Docket Number:	12-AFC-03
Project Title:	Redondo Beach Energy Project
TN #:	201163
Document Title:	Redondo Beach Energy Project Data Request Set 1B (Nos. 48-66)
Description:	Data Request Set 1B (Nos. 48-66)
Filer:	Alicia Campos
Organization:	California Energy Commission
Submitter Role:	Commission Staff
Submission Date:	11/12/2013 2:14:49 PM
Docketed Date:	11/12/2013

Regarding: **REDONDO BEACH ENERGY PROJECT (12-AFC-03)**
DATA REQUEST SET 1B (Nos. 48-66)

**Energy Commission Staff's Data Requests Set 1B (Nos. 48-66)
November 12, 2013**

CAISO Western Los Angeles Local Reliability Sub-Area

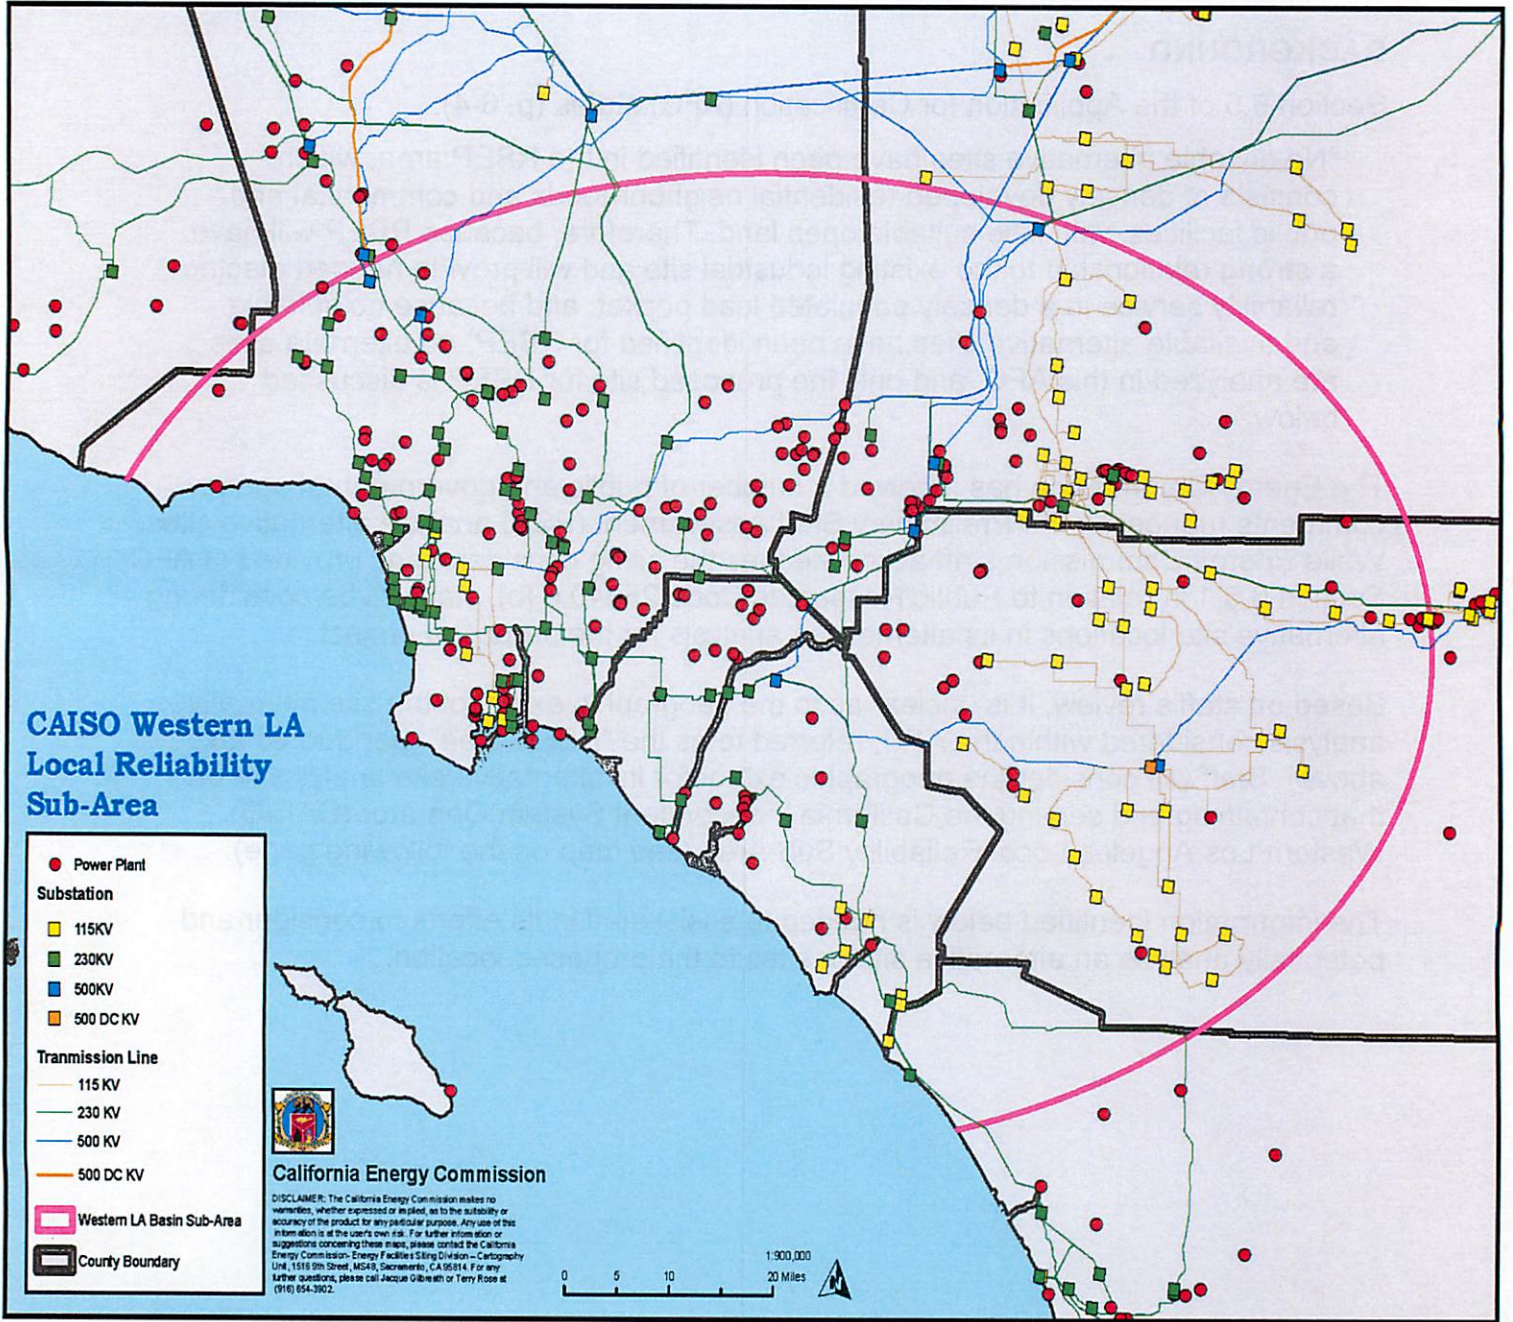
Based on staff’s review, it is unclear as to the geographic extent of the site alternatives analysis considered within the AFC, referred to as the “RBEP area” (per quoted text above). Staff will consider the geographic extent for its alternative site analysis to be that containing and serving the California Independent System Operator (CAISO) Western Los Angeles Local Reliability Sub-Area (see map on the following page).

48. Please identify alternative site(s) within the CAISO Western Los Angeles Basin Local Reliability Sub-Area that provide adequate size to site a 496 megawatt (MW) facility similar or identical to that of the proposed RBEP. When addressing this request, staff asks the applicant to please provide and consider the following in the response:
